**Verdura[®] 40/60 Retaining Wall Feasibility Design
and Response to Plan Review Comments
from City of Lake Forest**

Project:
**Portola Center Project (South Parcel), TTM 15353
Lake Forest, CA**

**SRD Project No: 0704-034A
August 10, 2012**

Subject: Portola Center Segmental Retaining Walls for the North and
South Parcels – Preliminary Structural Plan Review

Figure 48. Design rules for superimposed walls.

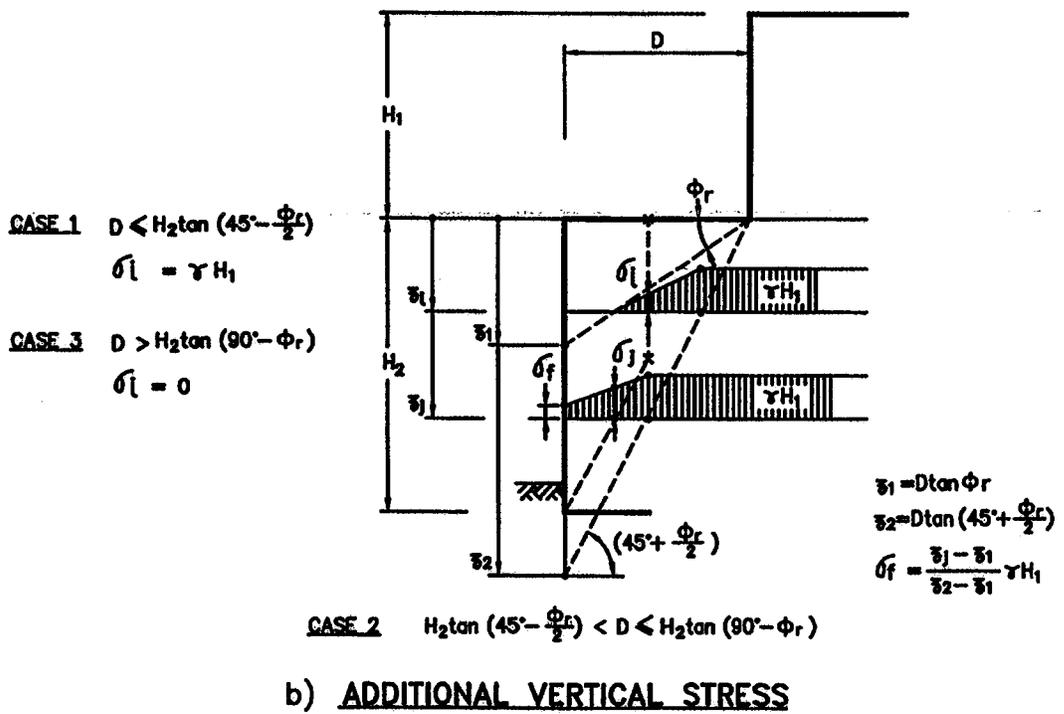
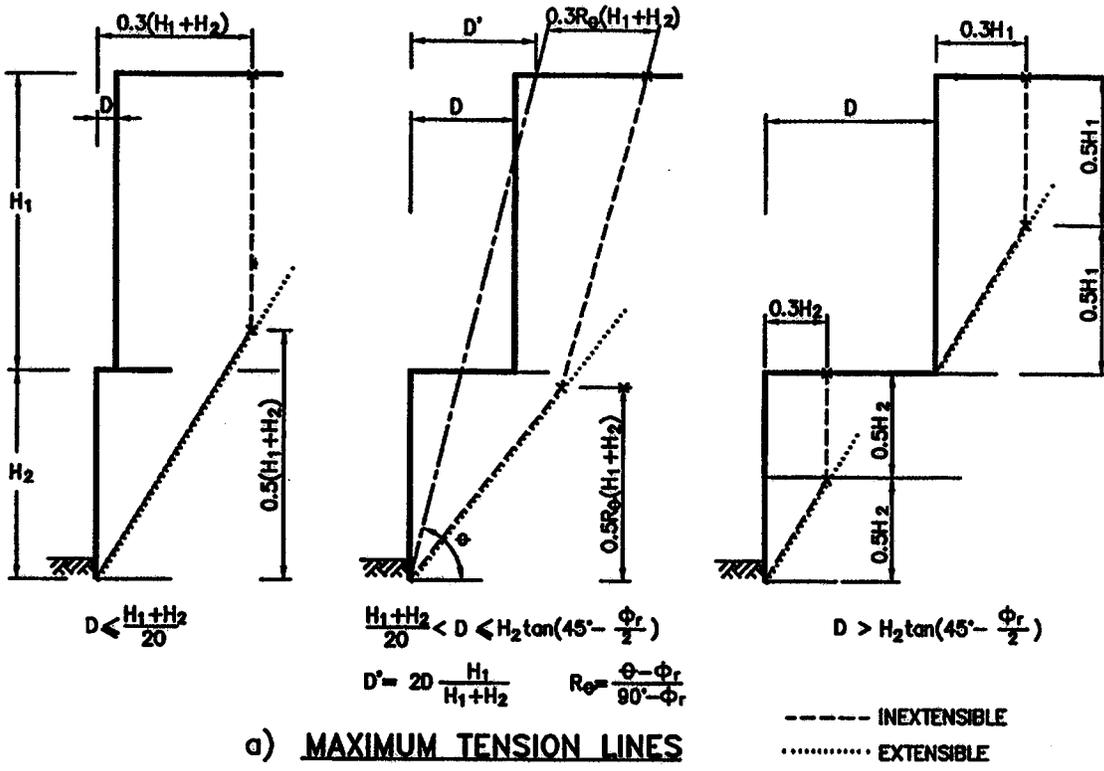
- S6. Section 9.13.12 of the Geotechnical Report specifies that MSE walls in excess of 60' high should be constructed using metallic reinforcement in the reinforced zone to prevent significant deformations that would be expected in similar height walls reinforced with geosynthetic reinforcement. Please verify if metallic reinforcement should be used at walls over 60' in height.

SRD Response #S6 (Duplicate Question #) – The proposed *Verdura*[®] retaining walls have a maximum exposed height of 30 feet; however the walls are designed in some cases in a superimposed (terraced) condition creating heights in excess of 60 feet due to the 2:1 separation slopes and required embedment depths. The structural design methodology for terraced wall and/or an overall single height wall design is controlled by the offset distance between the walls. The following relationship recommended by Federal Highway Administration (FHWA) determines the type of analysis performed:

Per the FHWA design manual, for small upper wall offsets (where $D \leq 1/20 * [\text{maximum } 36 + 38] \approx 4$ feet), it is “assumed that the failure surface does not fundamentally change...The walls should be designed as a single wall...” Please see the attached excerpt from the FHWA design manual at the rear of text that further details this information.

For the subject site, the minimum offset between walls is on the order of 20+ feet. The “D” equation is not satisfied with this geometry, so the walls are designed in a terraced condition and internal stresses within the wall are significantly reduced. Our feasibility design for the terraced condition incorporates the use of “high-strength” geogrid reinforcement for these lower stresses. Steel reinforcements are not necessary for the proposed wall geometries. Additional information regarding terraced wall or independent wall design is outlined within the body of this report.
